**Reference** 23/1124/MFUL

**Location** Pound Road Bess Land North East Of  
Axminster National Grid Substation Pound Road  
Hawkchurch

**Proposal** The installation of a battery energy storage  
system with associated infrastructure and  
works.

**PLANNING APPLICATION REF. 23/1124/MFUL**  
**POUND ROAD BESS**  
**DSFRS RESPONSE**

SCALE: 1:250	DATE: 09.08.23	DRAWN: KVT	CHECKED: RR	APPROVED: JD
JOB NO: 2203-080		DRAWING NO: SP02		REVISION: -

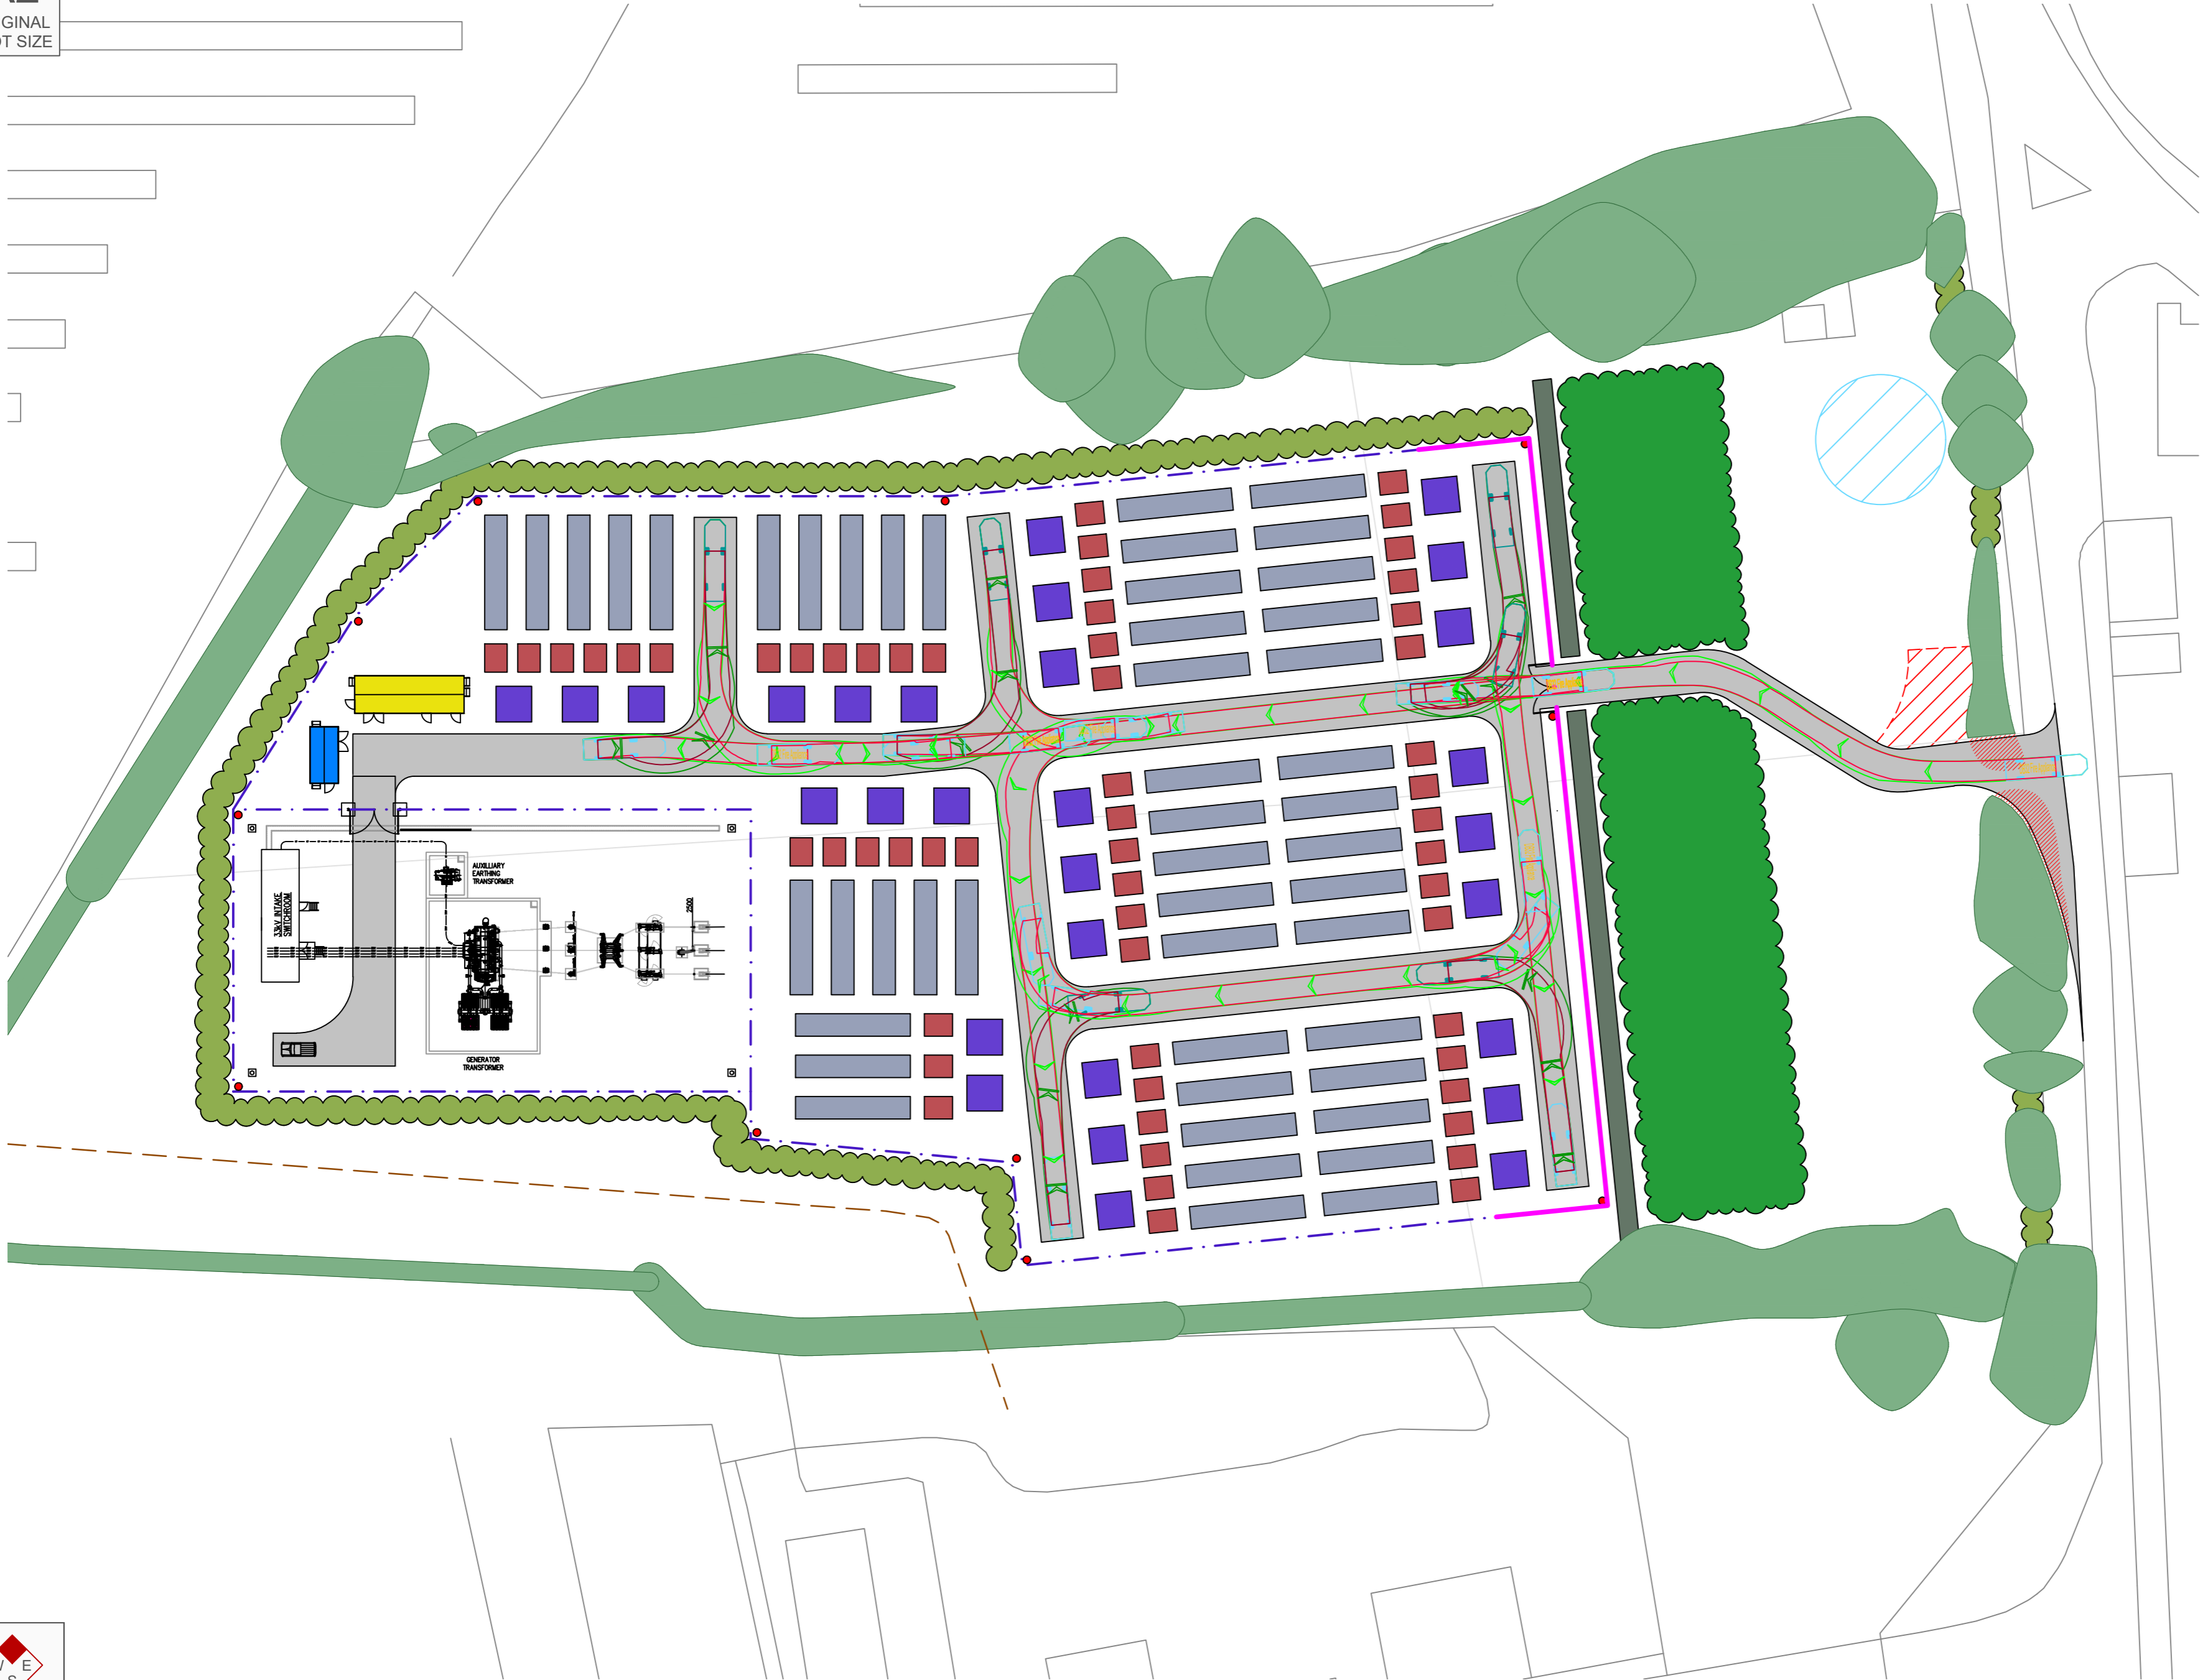
The response note includes plans which show the tracking of a fire engine within the internal roads and also show how a turning head could be accommodated at the site entrance to ensure vehicles and enter and exit in forward gear if needed.

Appendix 1 includes a plan (Drawing Ref. SP02) which identifies where a turning area is able to be positioned within the site, if necessary.

Such fire provisions could be accommodated within the design if required, the location for a water tank with a capacity of 450,000 litres have been shown on the plans in Appendix 1. It should be noted that the capacity of this tank is 222,000 litres more than that specified by the NFCC guidance (1,900 litres a minute for at least 2 hours, which equates to 228,000 litres).
